Addendum No. 2

Subject: Joseph W. Catharine Elementary School
2022 Classroom Modernization
SDP Contract Nos. 2022-008-G, 2022-008-P, 2022-008-E

Location: Joseph W. Catharine Elementary & Annex Schools
6600 Chester Avenue & 6900 Greenway Avenue
Philadelphia PA 19142

This Addendum No. 2, dated FEBRUARY 18, 2022, shall modify and become part of the proposed Contract Documents of the work of this project. Any items not mentioned herein, or affected by, shall be performed strictly in accordance with the original Contract Documents, unless modified by prior addenda.

DRAWING NO.
ED101

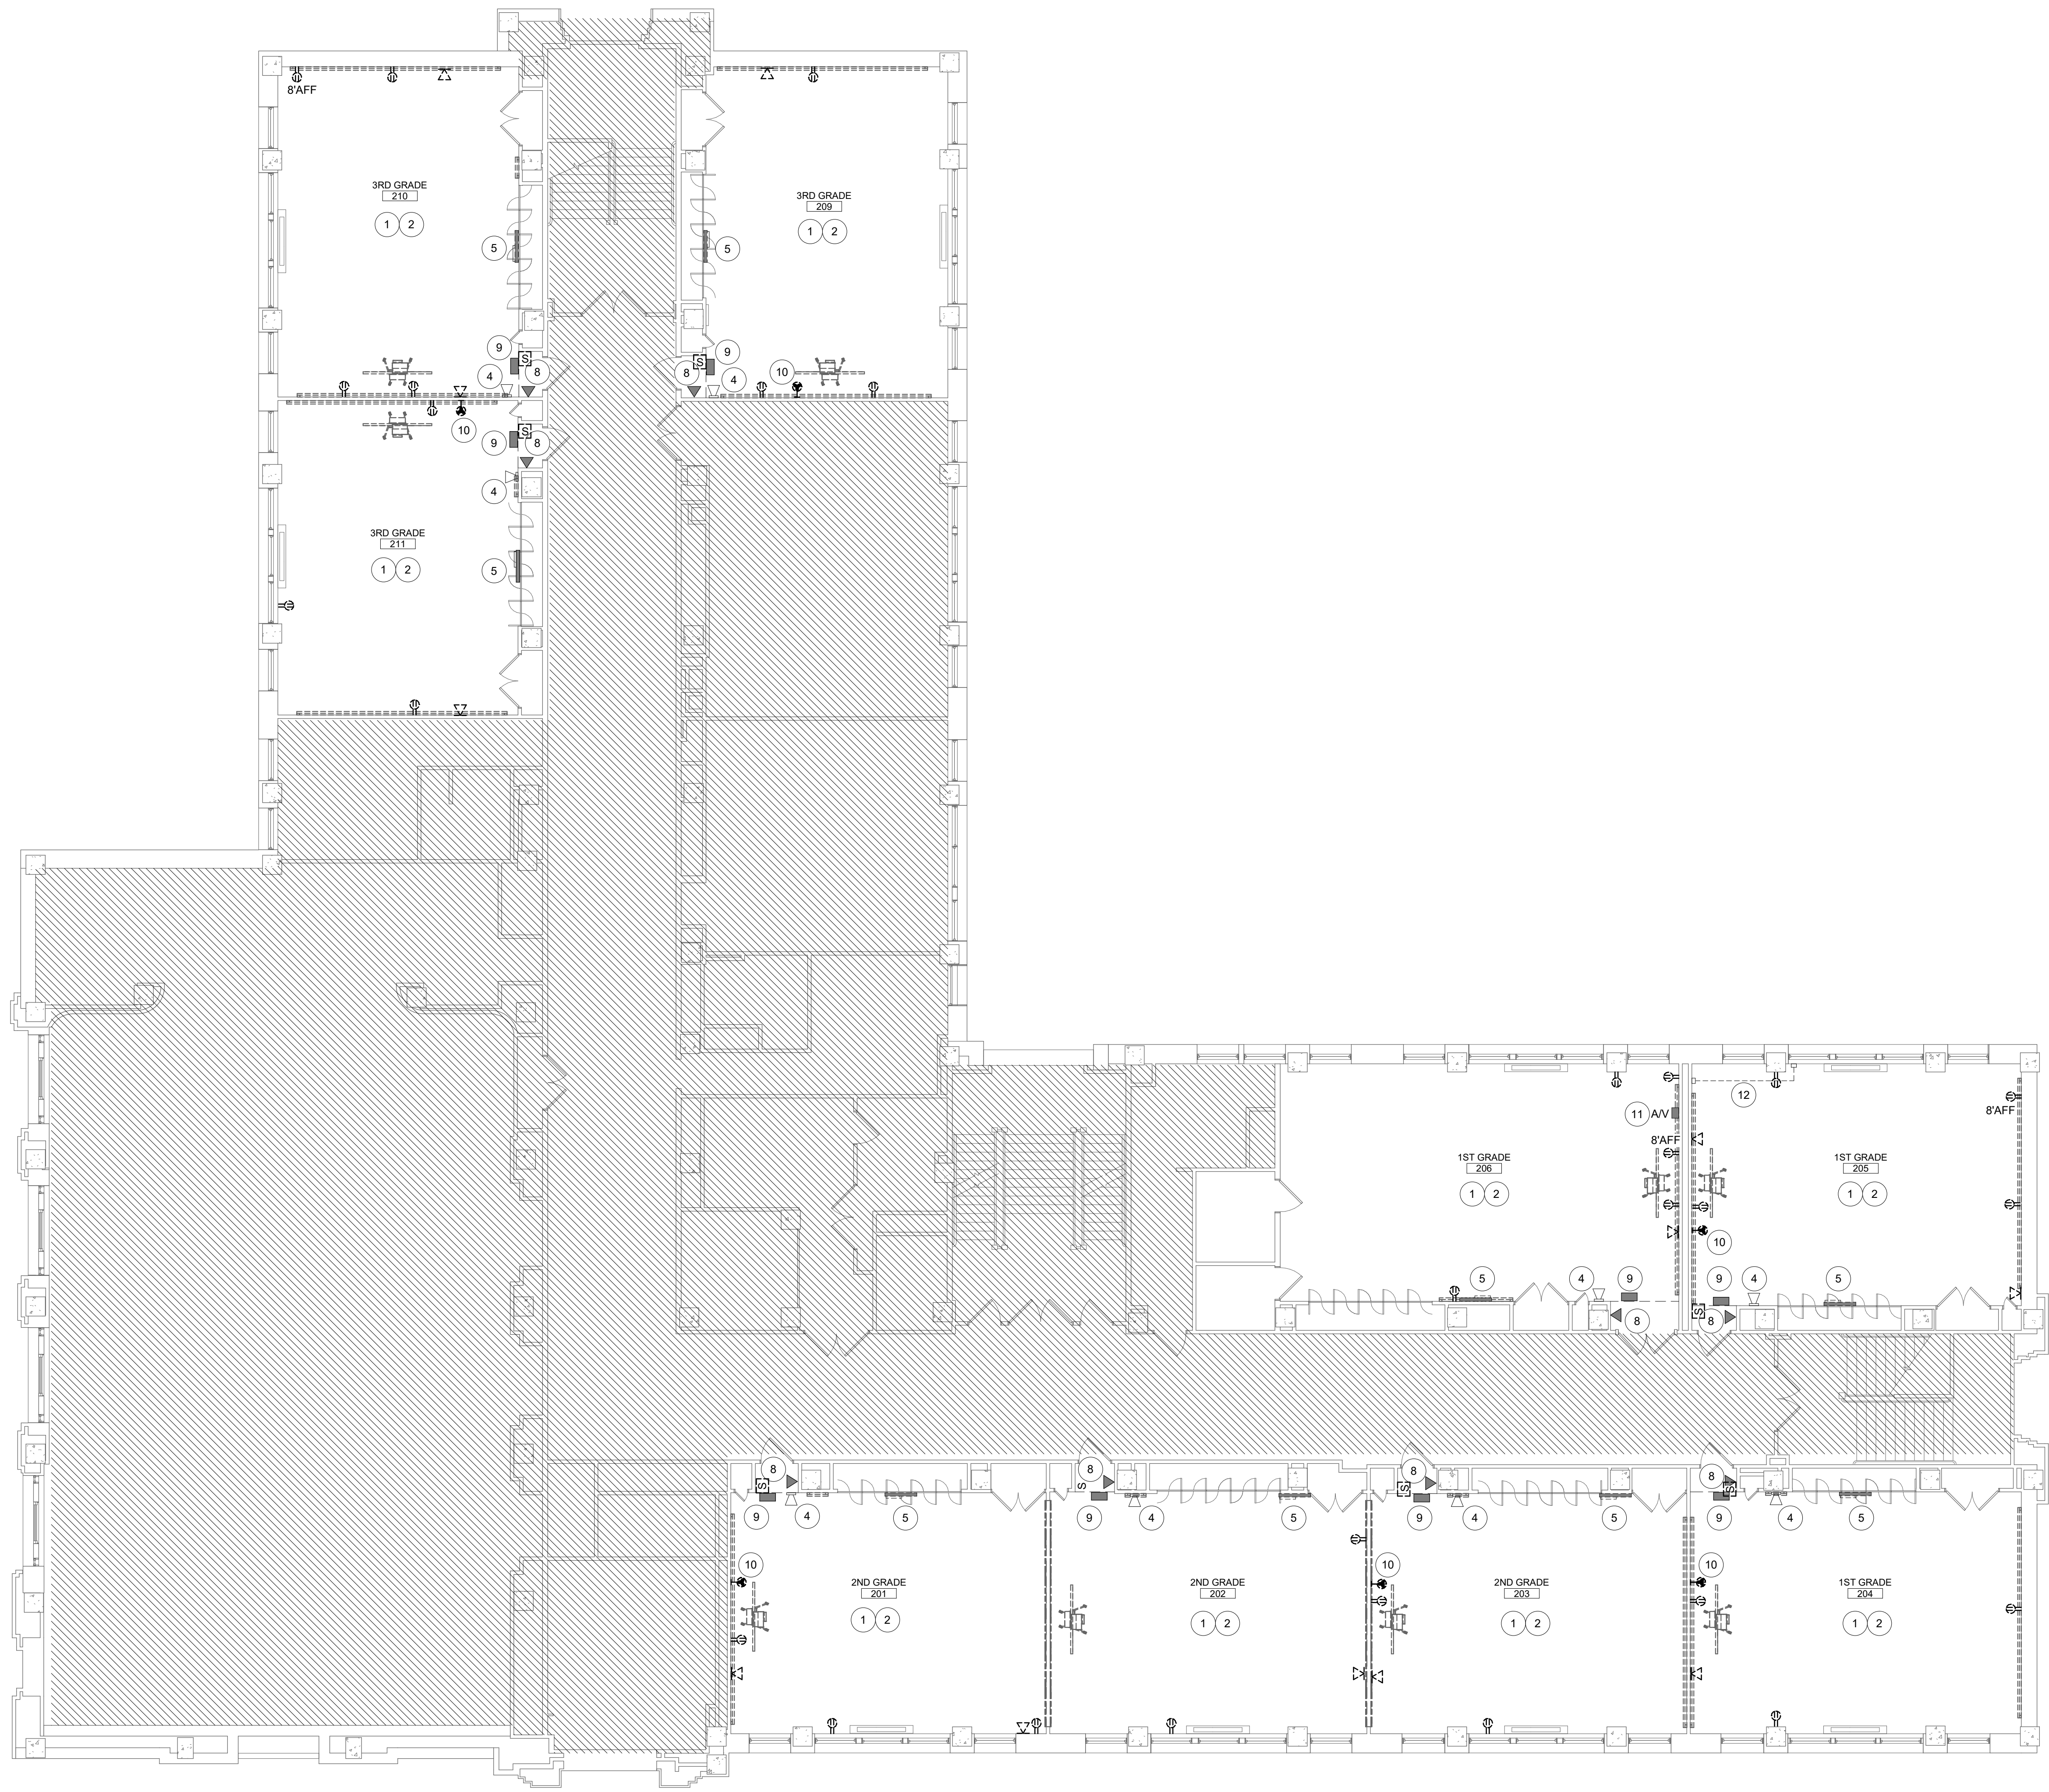
24. **Question:** Drawings ED101/ED102/E100-A and A100-B demo keynote #3 states to provide temporary support for existing ceiling mounted speakers to remain. Ceiling mounted speakers are not shown in any room. Please clarify how many speakers are in each classroom.

Response: Keynote 3 locations removed from the main building – refer to revised drawings ED101, ED102. Ceiling mounted speakers are to remain in the annex building – refer to drawings E100-A and E100-B.

DRAWING NO.
E102

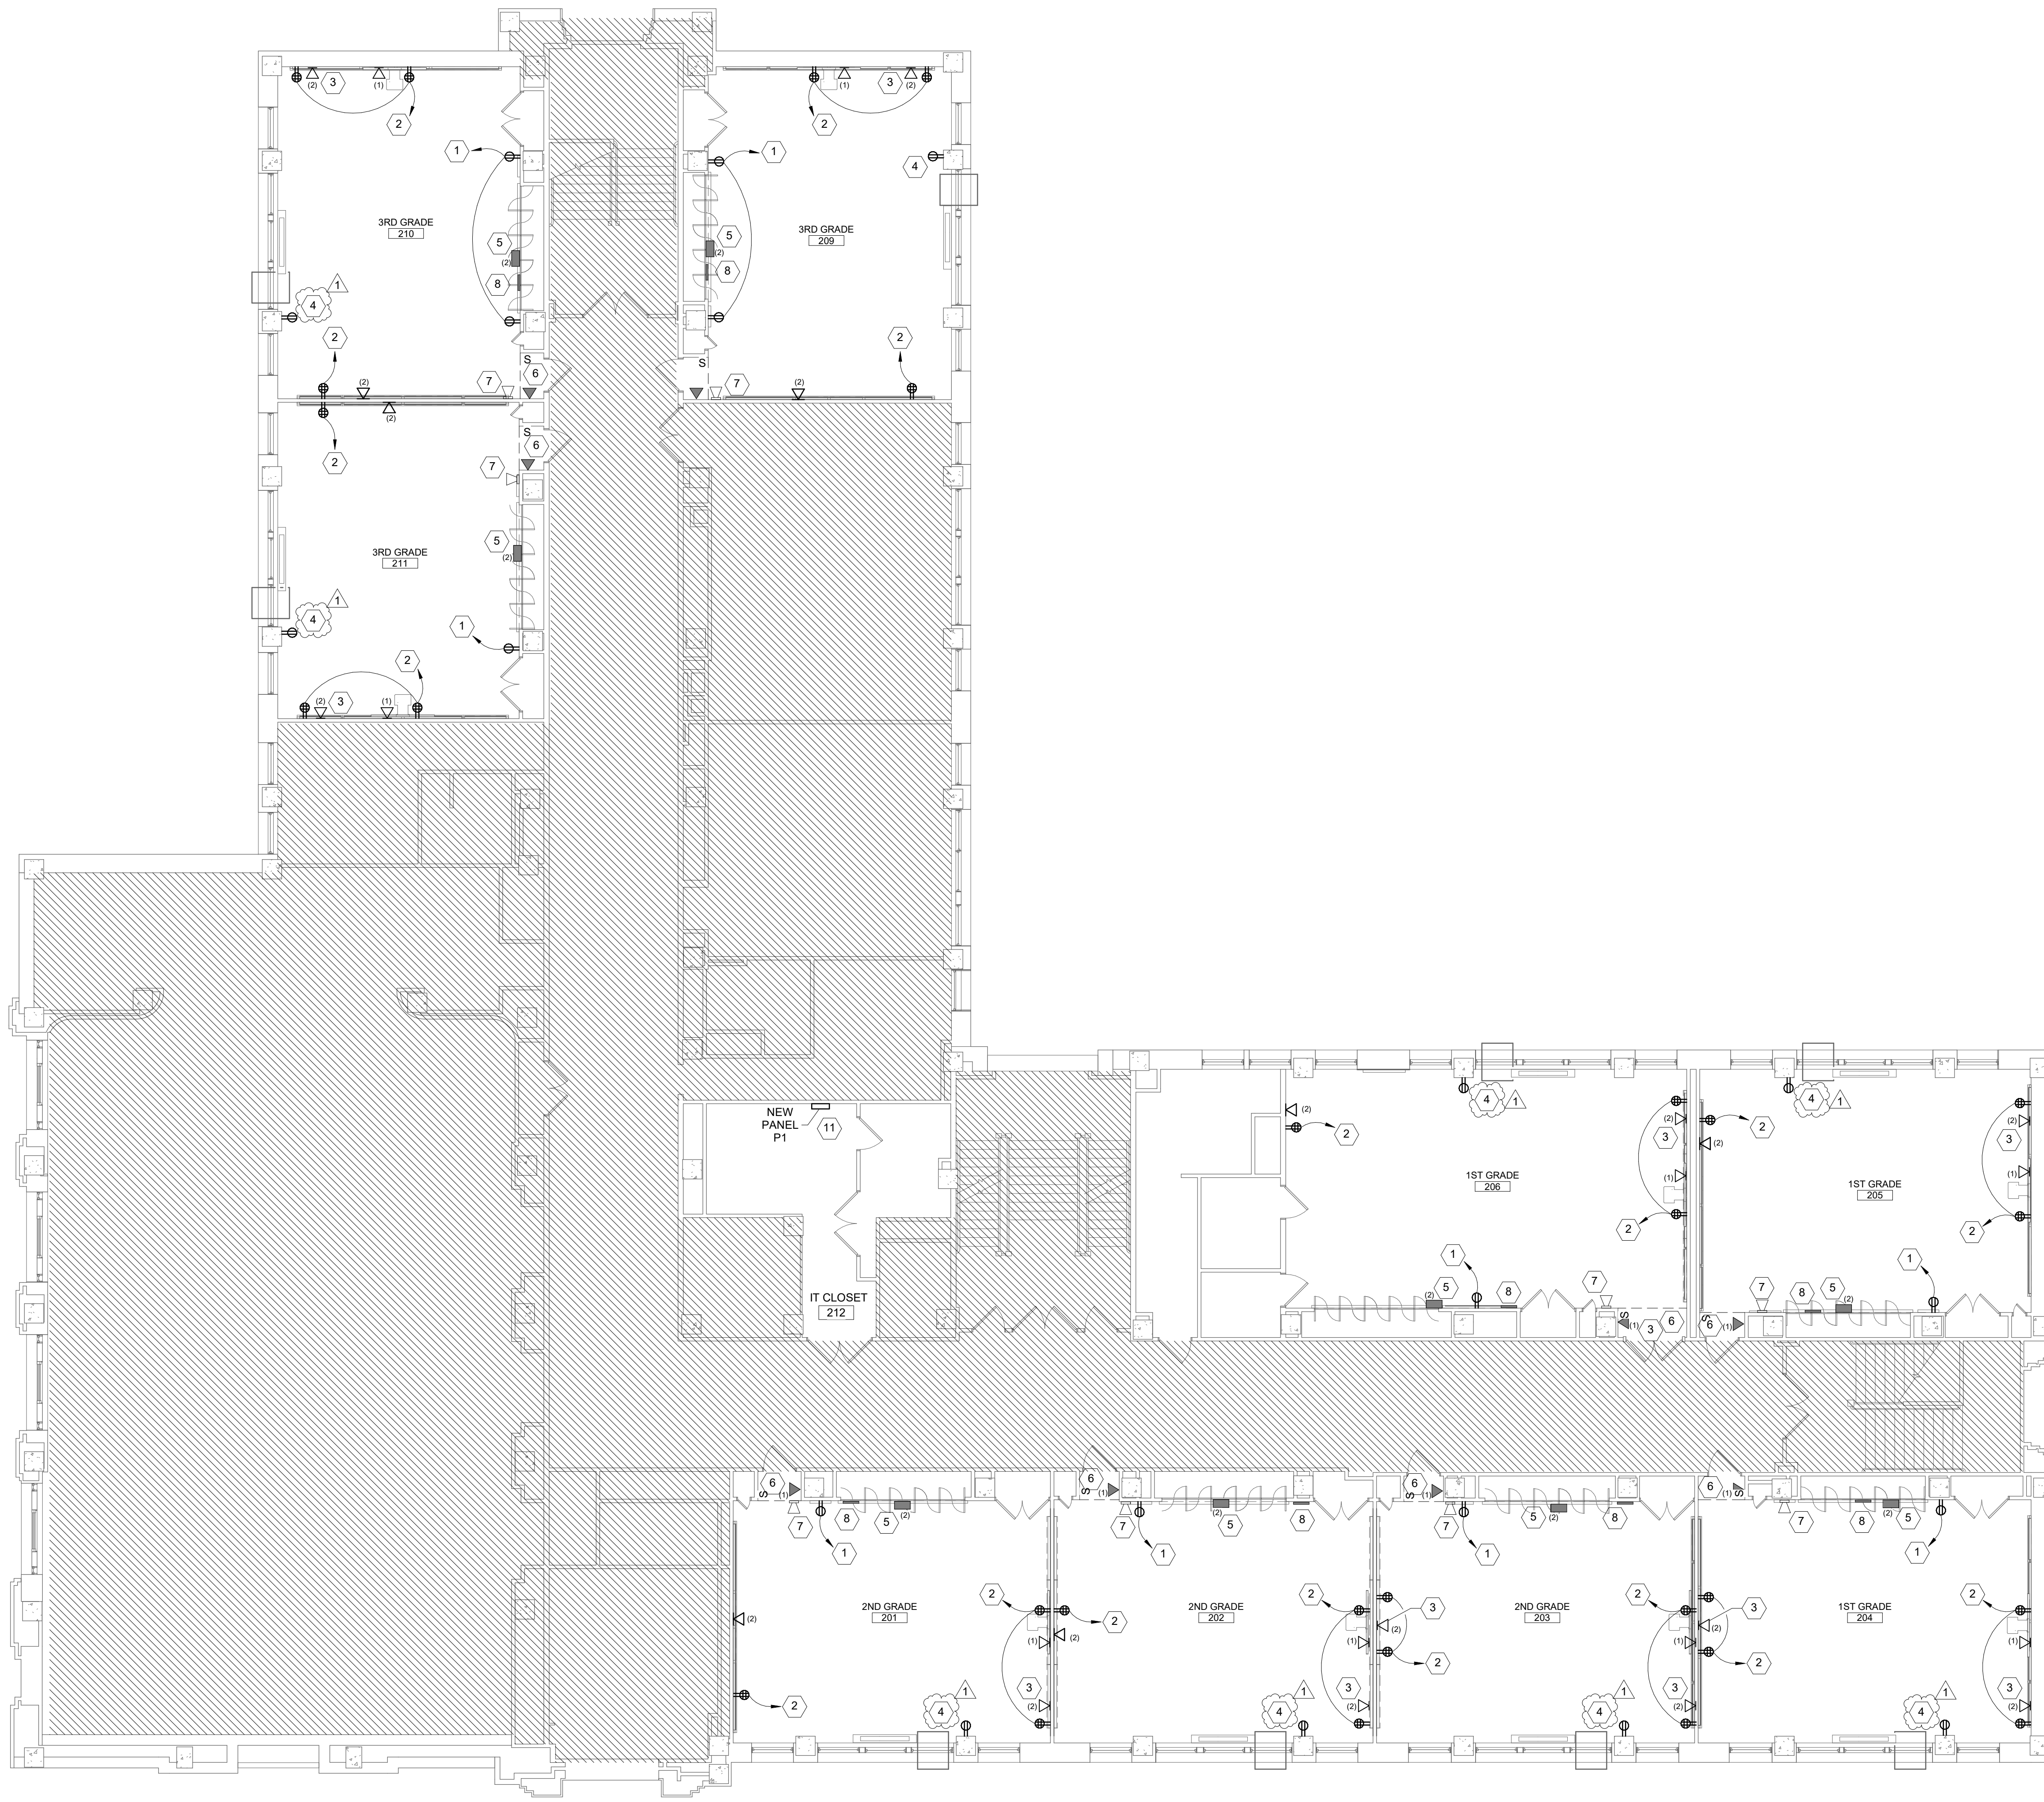
5. **Question:** What is the location of the MDF and IT closet?

Response: Refer to revised E102 for IT Closet #212 location.

Response: Refer to revised E102 for IT Closet #212 location.
